##### **I.1.a.h 2251 Lydia Street - Heritage Alteration Permit with Variance Application No. 00015 and Development Permit with Variances Application No. 00040 (Fernwood)**

## Committee of the Whole Report

**Subject:** Development Permit with Variances Application No. 00040 for 2251 Lydia Street

PROJECT TYPE  
NEW RESIDENCE-SPD  
SITE @  
LOT 3 DENHAM ST.  
FOR: CUNNING  
DRAWN BY: Alan Bissan  
DRAWING NO.  
A-2 of 3

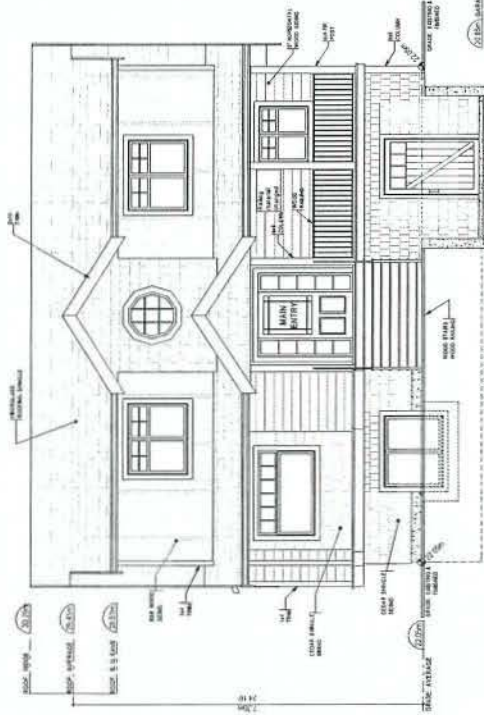
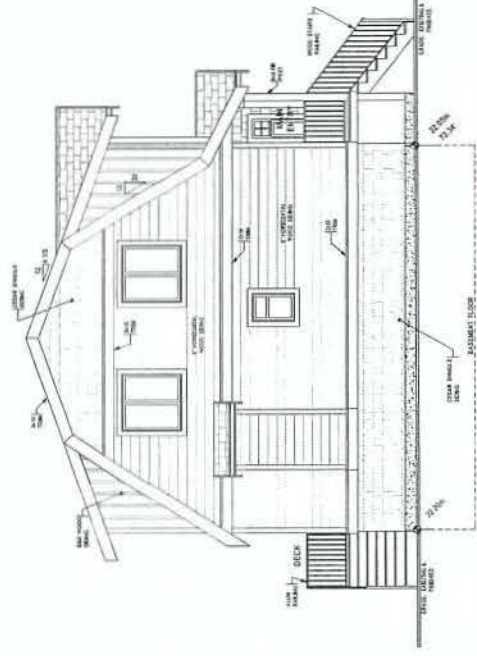
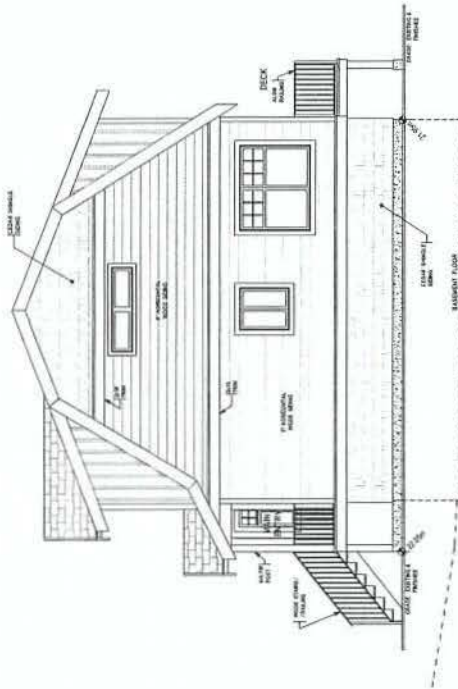
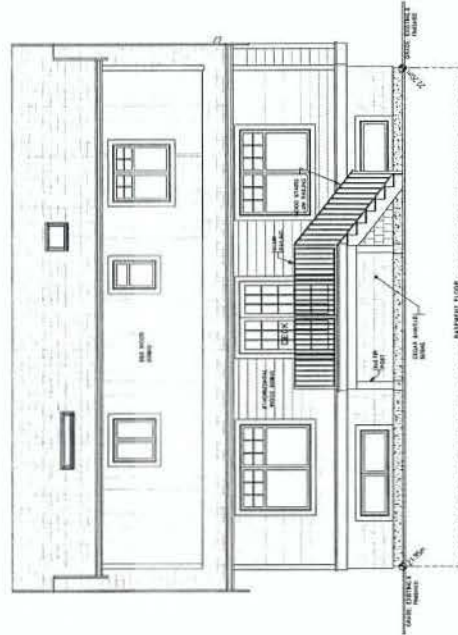
Generally, the proposal does not form a positive relationship with the street nor is there a relationship to local context. This is reflective of the building massing, roof form and pitch, fenestration, lack of articulation, competing architectural elements, materials and colours and inclusion of a below-grade bike storage area.

It is the opinion of staff that further design refinement is needed to create a more positive street relationship, specifically that the following be considered:

- reduce the area of the upper storey
- redesign the barn style roof and/or redesign dormers that are more integral to the roof structure
- simplify the fenestration of the front façade to achieve a more cohesive design and to be more in keeping with neighbouring properties
- simplify the materials to form a more cohesive design
- change the bicycle storage access from the front of the house to the side or rear, and reduce the width of the ramp/grade change and reduce the amount of additional pavement as the width is excessive for bike access.

- a. revise the design of Lot 2 (Lydia Street) to improve the street relationship and to change the size and/or glazing of windows on the south elevation; and
- b. revise the design of Lot 3 to create more consistency with the *Small Lot House Design Guidelines*.
